Response to Comments

Master Plan Update Improvements at Seattle-Tacoma International Airport

Permit: 1996-4-02325

April 2001

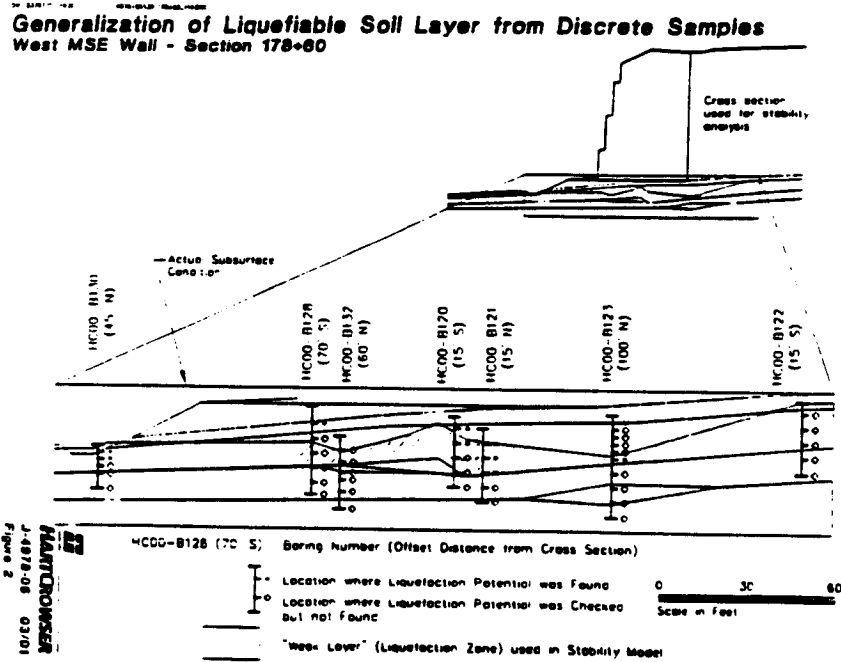
A spatial analysis of potential liquefaction was completed along with a simulated spatial analysis based on a Monte Carlo type approach (Hart Crowser, 2001. *DRAFT Geotechnical Engineering Analyses and Recommendations, Third Runway Embankment, Seattle-Tacoma International Airport, SeaTac, WA, Pages 8 through 10, and A-6 through A-12, March 2001*). In some areas, the Port's consultant (Hart Crowser) did find specific seams or zones of potentially liquefiable soils; in other areas there are only discrete, isolated samples that analysis indicated are subject to liquefaction, and in these areas Hart Crowser found no geologic basis for interpolating contiguous liquefiable conditions. Analyses using the most conservative interpretation showed stability exceeded the target factor of safety.

Numerous cross sections for both MSE walls and the embankment were analyzed for stability based on conservative assumptions, using "weak seams" to represent continuous layers of liquefaction-susceptible soils. In several cases the Port's design analyses generalized liquefiable soils to be more extensive than actually exist in order to evaluate the effect on stability and to design the extent of subgrade improvement, see Figure 2 for example. Figure 2 shows how the Port conservatively modeled a few liquefiable samples as a continuous layer, for stability analysis.

In addition to stability analysis based on graphical interpolation and extrapolation of liquefiable soils, the Port's geotechnical engineer considered liquefaction in a statistical manner, to compare general trends in liquefaction potential based on four general subdivisions (North MSE Wall, 2H:1V Slope, West MSE Wall, and South MSE Wall). This comparison included considering the relative distribution of soils that would liquefy due to different size earthquakes, and what the resulting effect would be on soil strength.

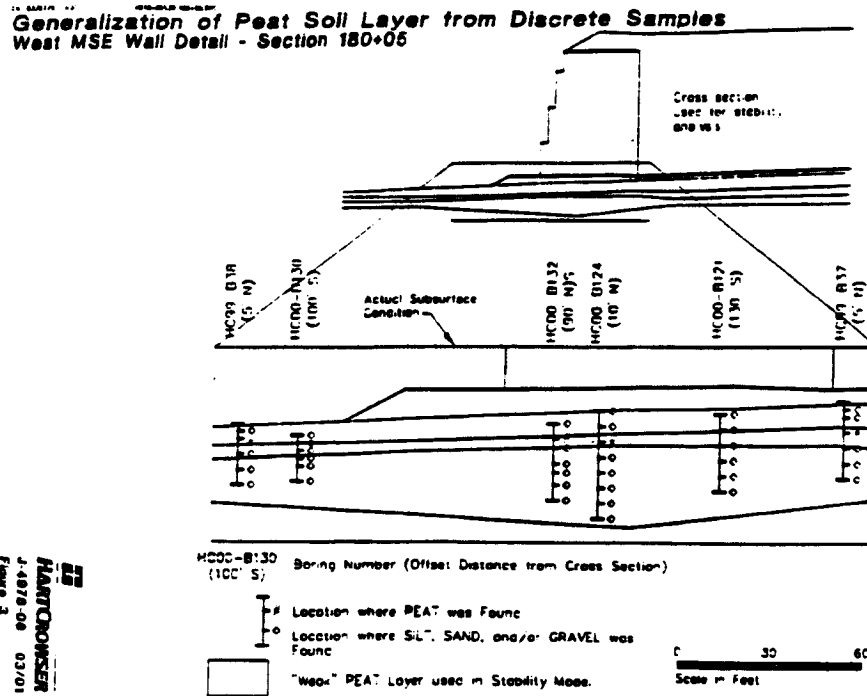
The comment asserts that the Port's pseudo-static (seismic) stability analysis is improper, and that a more "proper" analysis should be performed to search for the critical failure surface independently of the static analysis. However, it is the Port's belief that there is no theoretical justification, or code requirement that justifies the suggested approach. The pseudo-static approach used by the Port represents the standard of practice for this type of analysis. Searching for a critical surface with the pseudo-static acceleration

component included in the search is unreasonably overly-conservative, and for this reason is not required by design standards such as the code developed for design of MSE walls by the American Association of State Highway and Transportation Officials (AASHTO, 1996-2000 "Standard Specifications for Highway Bridges", 16th Edition, 1996, with current interim addenda through 2000) and the Federal Highway Administration (FHWA, 1997, Mechanically Stabilized Earth Walls and Reinforced Soil Slopes Design and Construction Guidelines, SA-96-071).

The Port recognizes that there are inherent limitations in the use of any pseudo-static, limit equilibrium type analysis to assess stability of slopes and MSE walls. The Port's engineers have addressed seismic stability recognizing the limitations in the pseudo-static method through the use of appropriate design parameters and factors of safety; use of post-liquefaction stability analyses, and in part by using a completely different approach (finite difference based deformation analysis) to provide an independent assessment of seismic stability.
